## FAQ 21-01: Unplanned Scrams with Complications for AP1000

**Plant:** Generic to AP1000 Reactors

**Performance Indicator:** IE04, Unplanned Scrams with Complications (USwC)

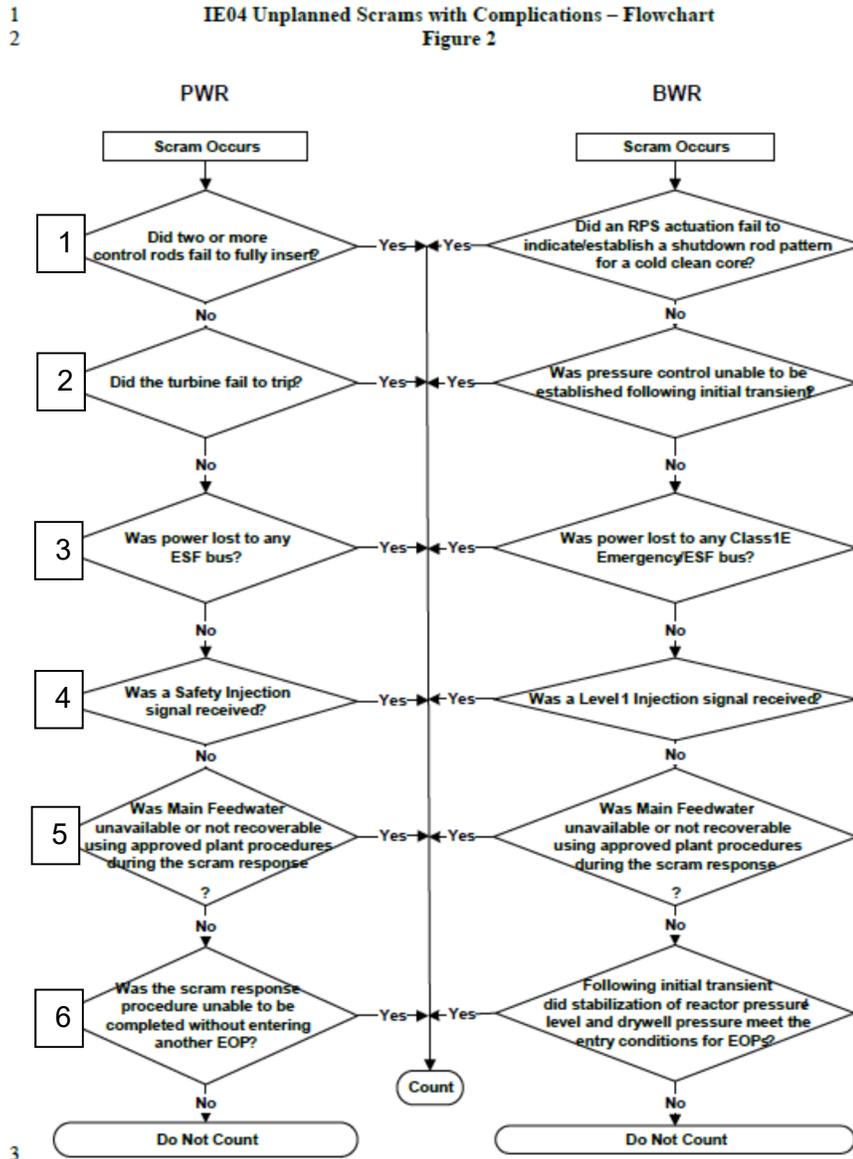
5. Conforming changes are needed in the depiction of PWR scram screening questions in Figure 2, as follows:
- a) For the third decision diamond, which reads, “Was power lost to any ESF bus?”, add the following footnote: “For AP1000: Was power lost to any battery backed Class 1E DC and UPS System (IDS) bus?”
  - b) For the fourth decision diamond, which reads “Was a Safety Injection signal received?”, add the following footnote: “For AP1000: Was a Safeguards Actuation signal received?”

see footnote<sup>3</sup>
